PLANNING COMMISSION REPORT
Regular Agenda -Public Hearing Item

PC Staff Report
11/15/10

**ITEM NO. 6 PRELIMINARY DEVELOPMENT PLAN FOR CROSSGATE DRIVE CASTIAS;
6.6 ACRES; 4700 W 6TH ST (SLD)**

PDP-9-3-10: Consider a Preliminary Development Plan for Crossgate Drive Casitas, approximately 4.6 acres, located at 2451 Crossgate Drive. Submitted by BG Consultants, Inc., for Corporate Holdings II, L.L.C., property owner of record upon application, Fairway L.C., current property owner.

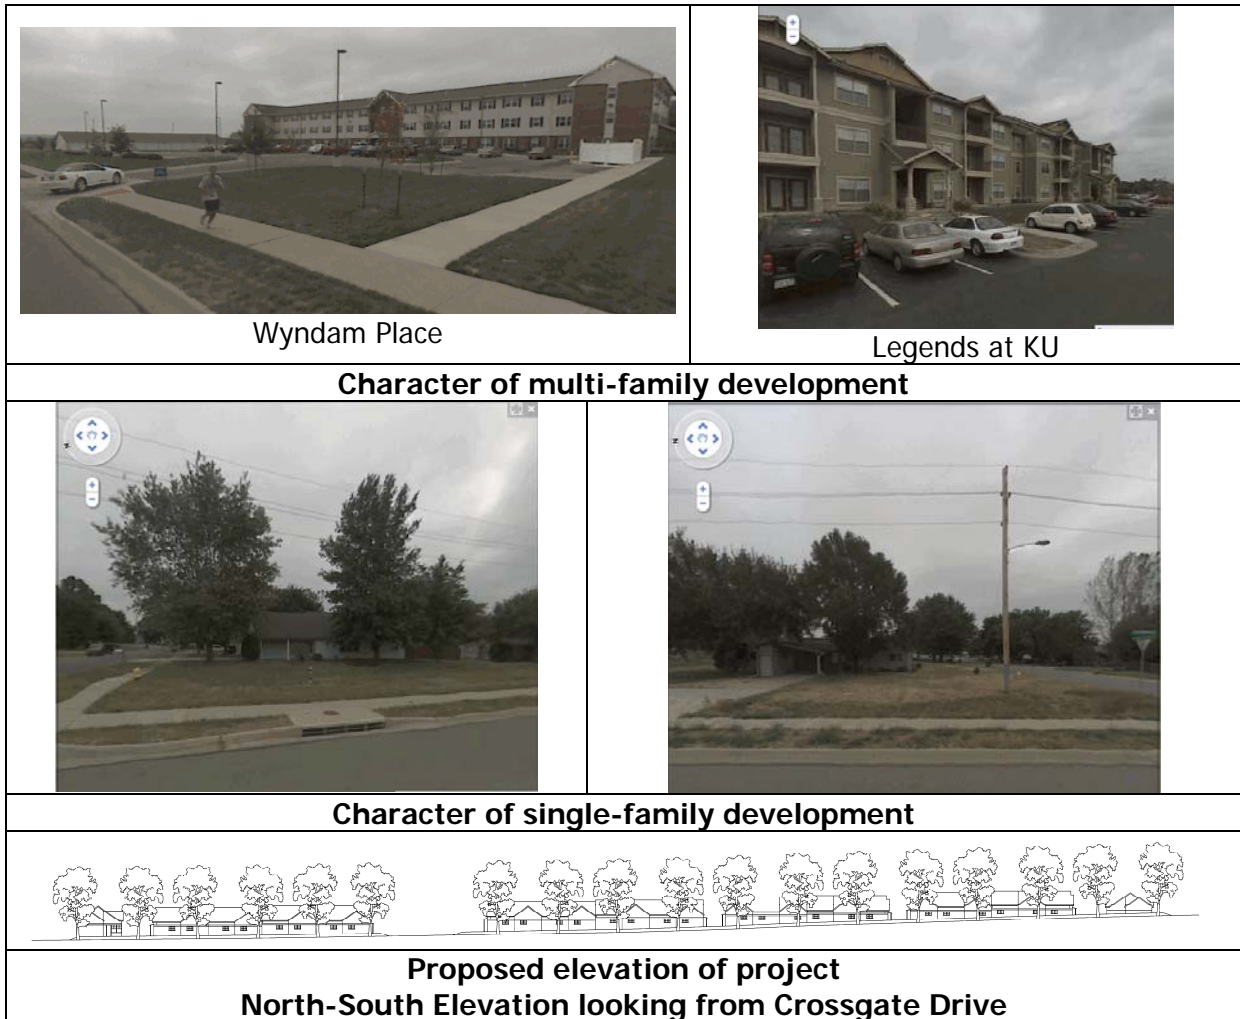
A concern expressed by Fire/Medical Staff during the review was the provision and retention of adequate access for emergency purposes. Access to a majority of the development can be provided from either Crossgate Drive or the internal parking lot, thus providing two points of access as required by Code. This layout satisfies the Fire Code. To retain this accessibility, no fence shall be permitted along the front (Crossgate Drive) that will restrict or limit access to the property. This requirement shall be reflected on the face of the Preliminary and Final Development Plans and is a recommended condition of approval for the Preliminary Development Plan.

Staff Finding –The plan does make adequate provisions for public services, provides adequate control over vehicular traffic, and furthers the amenities of light and air, recreation and visual enjoyment.
